Proposal #03: 1000-20-71
Sign Bridge Repair & Replacement 2019
Locations on Stn Per Annual Plan
Var-Hwy
Southeast Region Wide

This is Addendum No. 02, which provides for the following:

ADDENDUM NO. 02

1000-20-71

Addendum No. 02
ID 1000-20-71
Revised Sheet 35
June 4, 2019

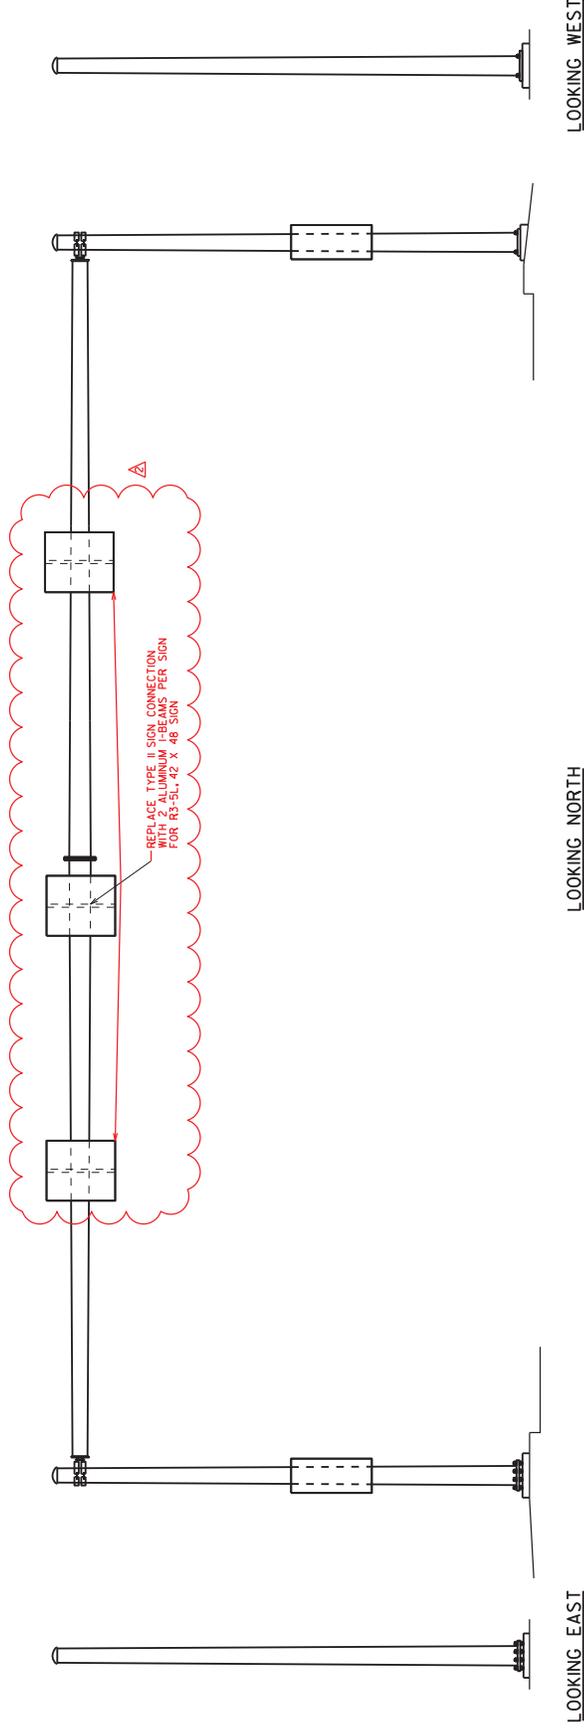
NO.	DATE	UPDATE	BID ITEM	QTY	SAD	BY
1

ITEM NUMBER	BID ITEMS	QUANTITY	REPAIR DETAIL SHEET NO.
637.2220	SIGNS TYPE II REFLECTIVE SH	6 EACH	5
SPV.00600.14	REPLACE TYPE II SIGN SUPPORT BRACKET WITH ALUMINUM I-BEAM	6 EACH	5

Addendum No. 02
ID 1000-20-71
Revised Sheet 51
June 4, 2019

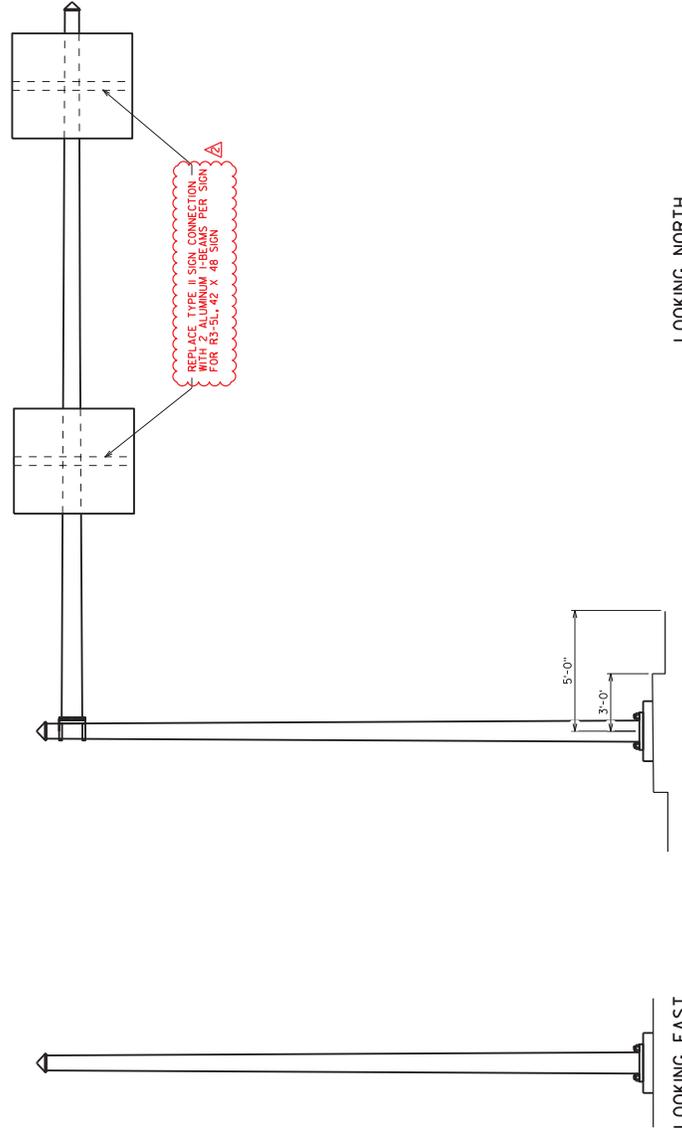
ITEM NUMBER	QUANTITY	REPAIR DETAIL SHEET NO.
SPV.C066.1H	4 EACH	5
REPLACE TYPE II SIGN SUPPORT BRACKET WITH ALUMINUM I-BEAM

Addendum No. 02
ID 1000-20-71
Revised Sheet 57
June 4, 2019

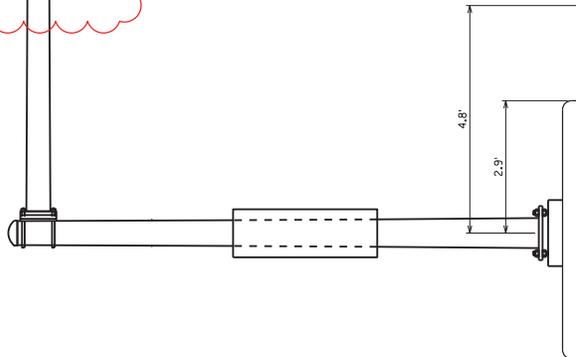
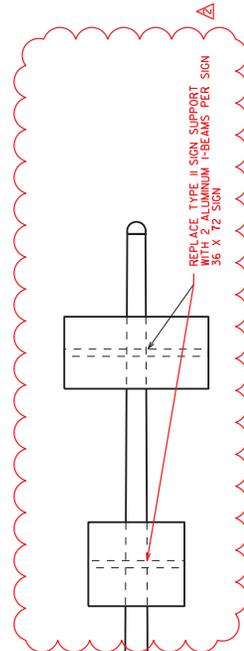
ITEM NUMBER	BID ITEMS	QUANTITY	REPAIR DETAIL SHEET NO.
SPV.0000.14	REPLACE TYPE II SIGN SUPPORT BRACKET WITH ALUMINUM I-BEAM	4 EACH	5

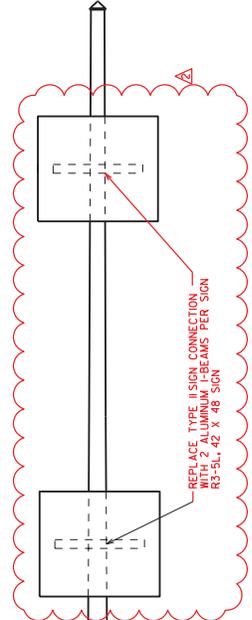
NO.	DATE	UPDATE	BID ITEM	AND	QTY	SAD	BY
5-31-19							
STATE OF WISCONSIN DEPARTMENT OF TRANSPORTATION STRUCTURES DESIGN SECTION							
STRUCTURE SE SIGN REPAIRS							
ITEM NUMBER	QUANTITY	REPAIR DETAIL SHEET NO.					
SPV.0060.14	4 EACH	5					
REPLACE TYPE II SIGN SUPPORT BRACKET WITH ALUMINUM I-BEAM			BRN		SAD		
			DD		SAD		
			SHEET 34				
S-40-901							57

Addendum No. 02
ID 1000-20-71
Revised Sheet 62
June 4, 2019

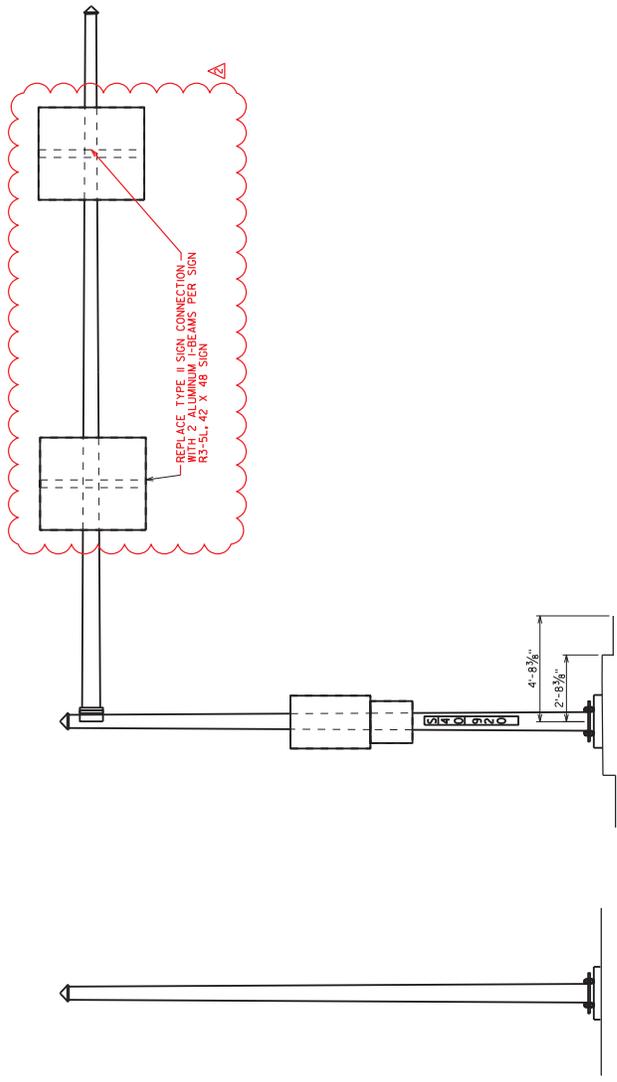
ITEM NUMBER	QUANTITY	REPAIR DETAIL SHEET NO.
SPV.0060.14	4 EACH	5
REPLACE TYPE II SIGN SUPPORT BRACKET WITH ALUMINUM I-BEAM

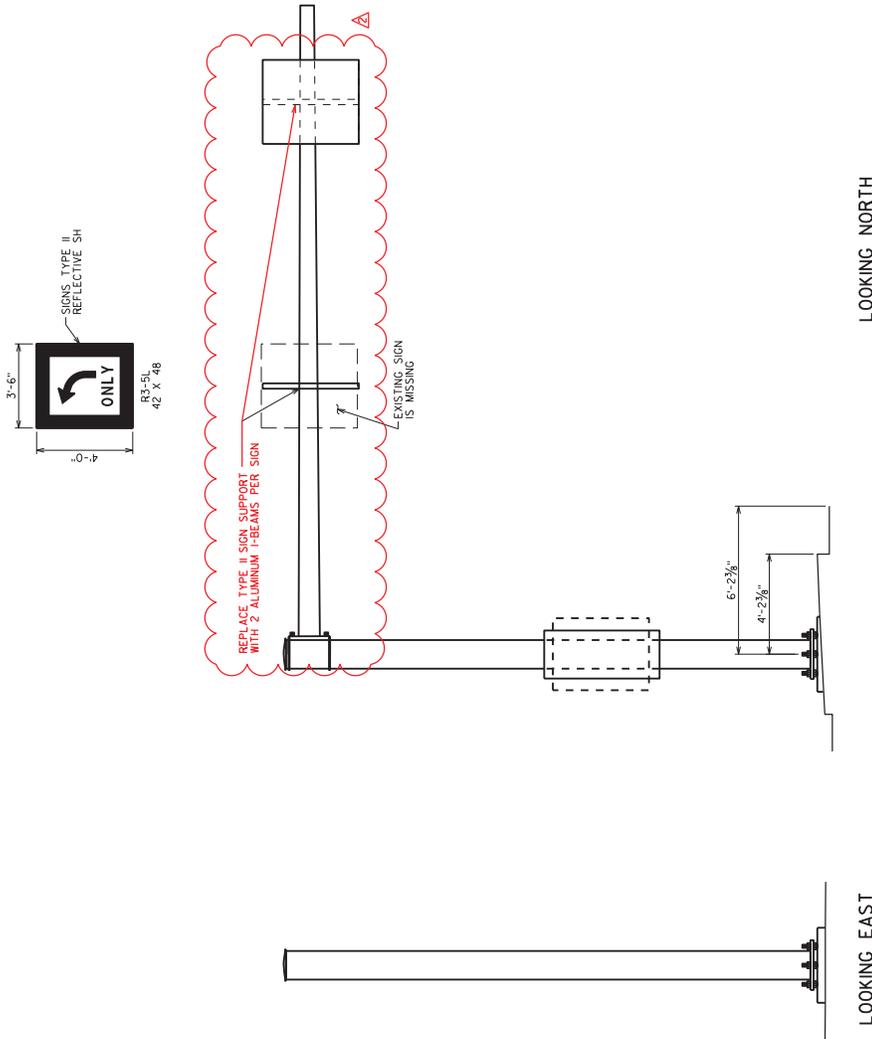
NO.	DATE	UPDATE BID ITEM AND CITY	SAD	BY
5-31-19				
STATE OF WISCONSIN DEPARTMENT OF TRANSPORTATION STRUCTURES DESIGN SECTION				
STRUCTURE SE SIGN REPAIRS			BRANS	SAD
			BY	DDO
			DATE	6/4/19
S-40-931			SHEET 39	
			62

ITEM NUMBER	BID ITEMS	QUANTITY	REPAIR DETAIL SHEET NO.
B37.2220	SIGNS, TYPE II REFLECTIVE SH	4	5
SPV.0060.14	REPLACE TYPE II SIGN SUPPORT BRACKET WITH ALUMINUM I-BEAM	4 EACH	5

Addendum No. 02
ID 1000-20-71
Revised Sheet 63
June 4, 2019

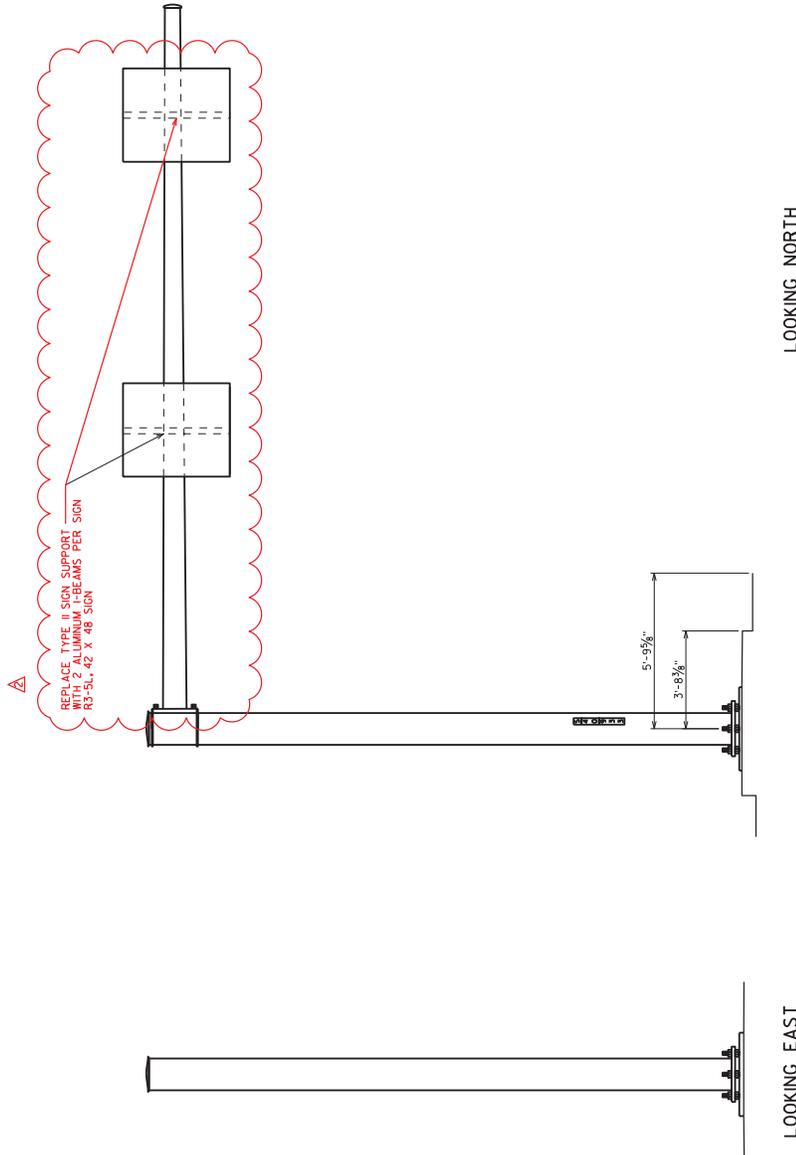
NO.	DATE	UPDATE BID ITEM AND QTY	SAD	BY
5-31-19				
STATE OF WISCONSIN DEPARTMENT OF TRANSPORTATION STRUCTURES DESIGN SECTION				
STRUCTURE SE SIGN REPAIRS				
BY	DATE	BY	DATE	
BRN	DDJ	BRN	DDJ	
S-40-933				SHEET 40
				63

ITEM NUMBER	BID ITEMS	QUANTITY	REPAIR DETAIL SHEET NO.
SPV.0060.14	REPLACE TYPE II SIGN SUPPORT BRACKET WITH ALUMINUM I-BEAM	4 EACH	5

Addendum No. 02
ID 1000-20-71
Revised Sheet 78
June 4, 2019

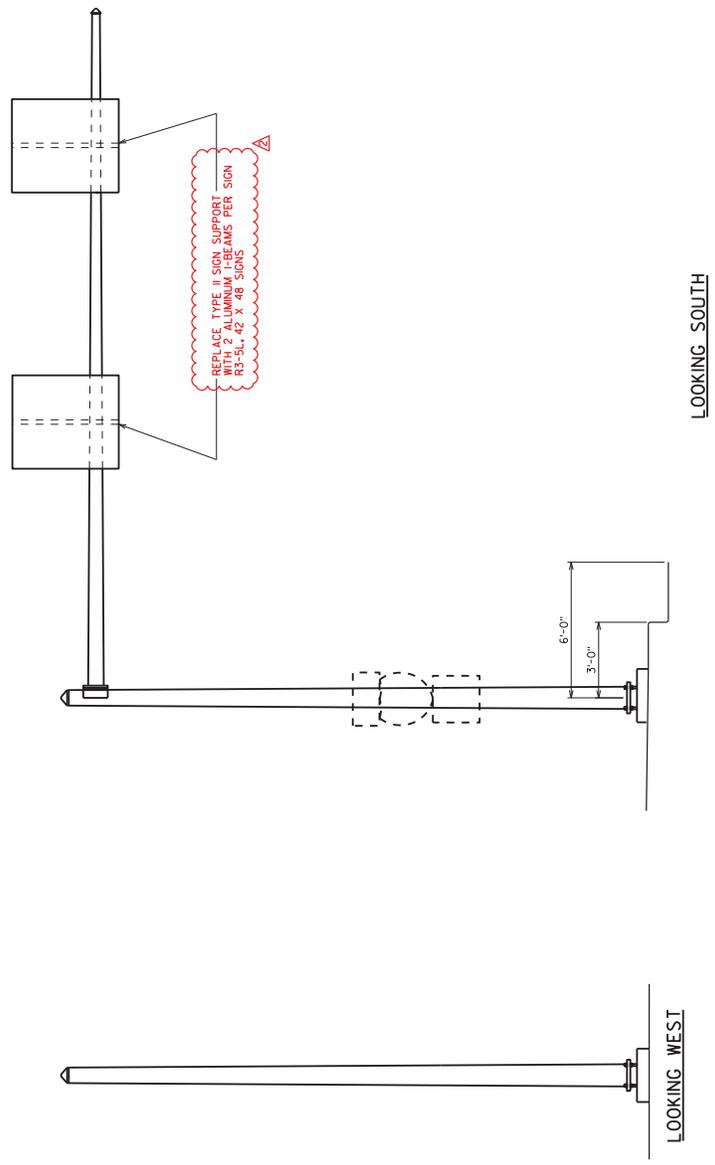
NO.	DATE	5-31-19	UPDATE BID ITEM AND QTY	SAD	BY
STATE OF WISCONSIN DEPARTMENT OF TRANSPORTATION STRUCTURES DESIGN SECTION					
STRUCTURE SE SIGN REPAIRS					
REPAIR DETAIL SHEET NO.	QUANTITY	BRANS: SAD			
5	4 EACH	DOS: CCB			
SHEET 55					
S-67-228					
78

ITEM NUMBER	BID ITEMS	REPAIR DETAIL SHEET NO.
SPV006C14	REPLACE TYPE II SIGN SUPPORT BRACKET WITH ALUMINUM I-BEAM	5
